# FORD PERFORMANCE

## Technical Service Bulletin – 30

### Optional Change

#### Heater Bypass Hose

## New Hose in Assembly

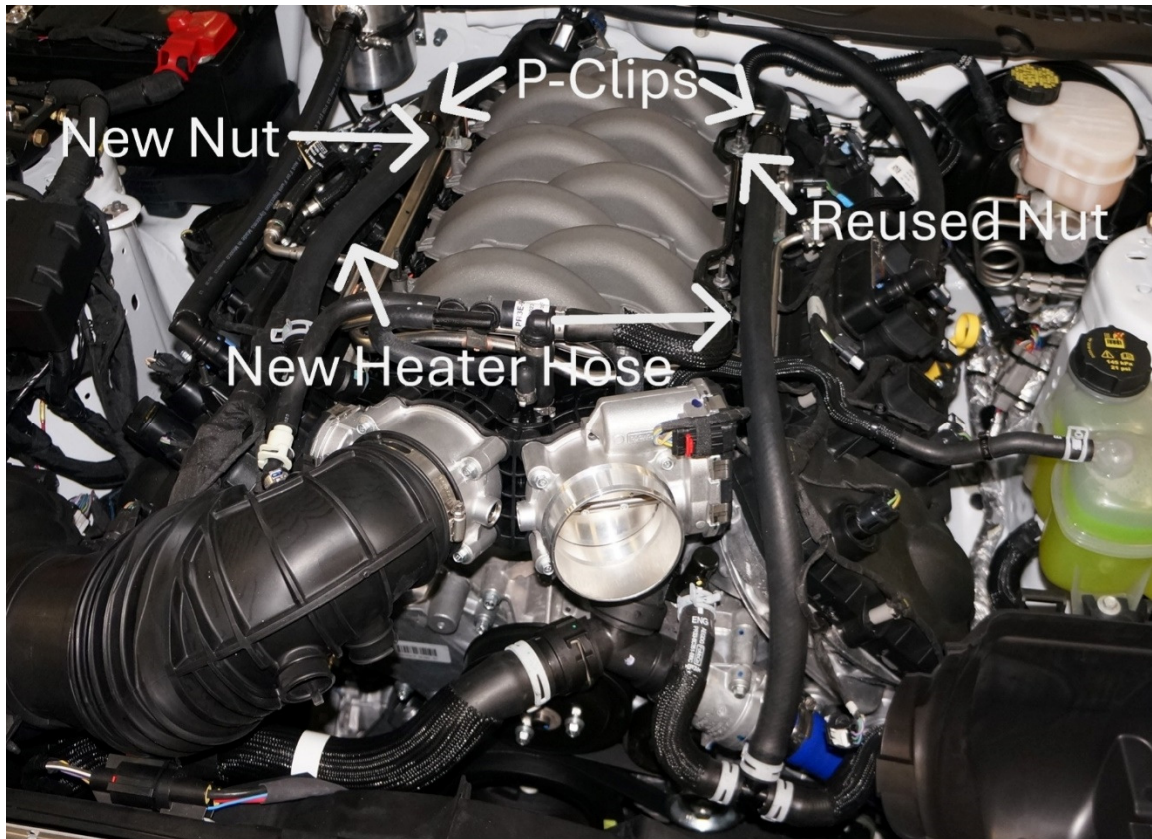
Purpose: To allow for more efficient packaging of the heater bypass hose under hood. This applies to vehicle serial numbers 1-40.

Original parts to be removed

- 1" Diameter x 3' length Heater Hose
- 3' Dash 12 Fire Sleeve

- 1" Diameter x 66.5" length Heater Hose
- Two, 1" P-Clips
- One Nut W711330-S442

New Hose Section
